NEWMAR CORPORATION

TECHNICAL SERVICE BULLETIN																		
DATE ISSUED	MODEL YEAR(S) AFFECTED		MODEL(S) AFFECTED		TSB #													
8/4/08	2004 - 2008		MADP, EXDP		352													
BRAND					TYPE													
All	<input type="checkbox"/>	American Star	<input type="checkbox"/>	Mountain Aire	<input checked="" type="checkbox"/>	All	<input type="checkbox"/>	T T <input type="checkbox"/>										
Cypress	<input type="checkbox"/>	Dutch Star	<input type="checkbox"/>	Kountry Aire	<input type="checkbox"/>	F W	<input type="checkbox"/>	C A <input type="checkbox"/>										
Northern Star	<input type="checkbox"/>	Kountry Star	<input type="checkbox"/>	Essex	<input checked="" type="checkbox"/>	D P	<input checked="" type="checkbox"/>	D B <input type="checkbox"/>										
Scottsdale	<input type="checkbox"/>	King Aire	<input type="checkbox"/>	London Aire	<input type="checkbox"/>													
All Star ME	<input type="checkbox"/>	Ventana	<input type="checkbox"/>	Bay Star	<input type="checkbox"/>

TSB05-170-003A

SUBJECT: Engine Oil Leak – Cummins C8.3, ISC, ISL, ISM

FIG. 4-1

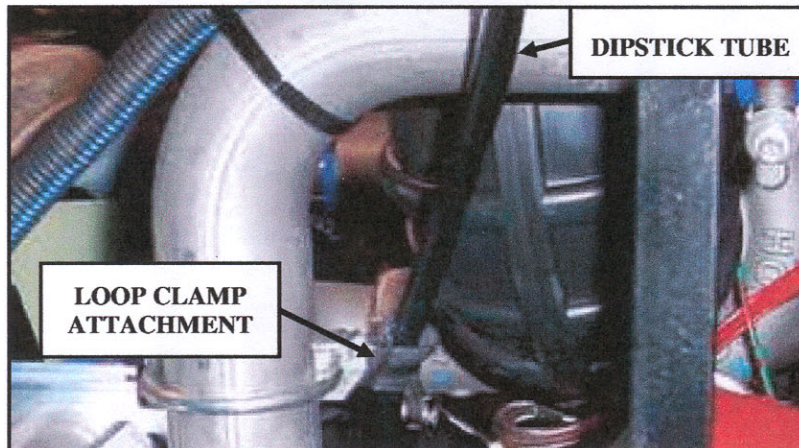
4. To prevent contact with the turbo or any other heat source, secure dipstick tube with the loop clamp provided to an appropriate location as shown in FIG. 4-1, FIG. 4-2, or FIG. 5-1.

Note: Plastic tube must be a minimum of 2.0 inches from the turbo unit or any heat source (i.e. turbocharger, exhaust piping, hot water piping, etc.)

FIG. 5-1

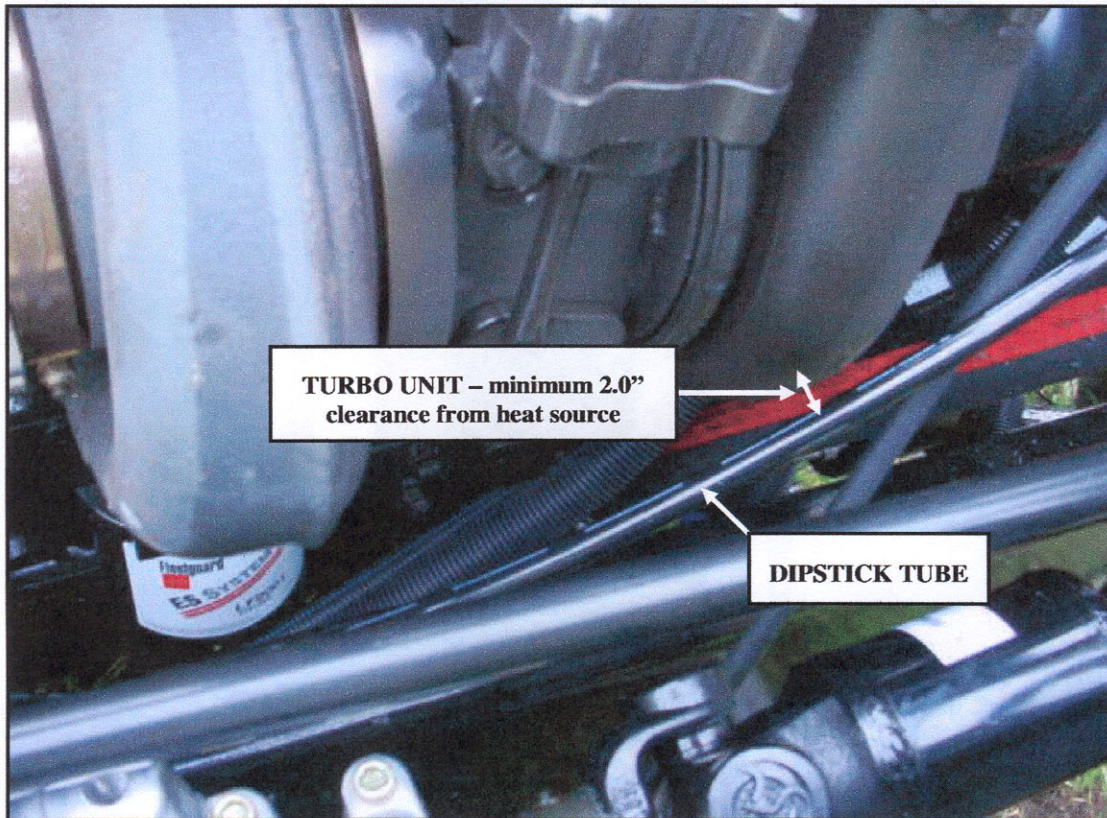
Note: Care must be taken with new tube installation and routing to not to kink the plastic tube, as this will cause resistance when inserting and/or removing the dipstick.
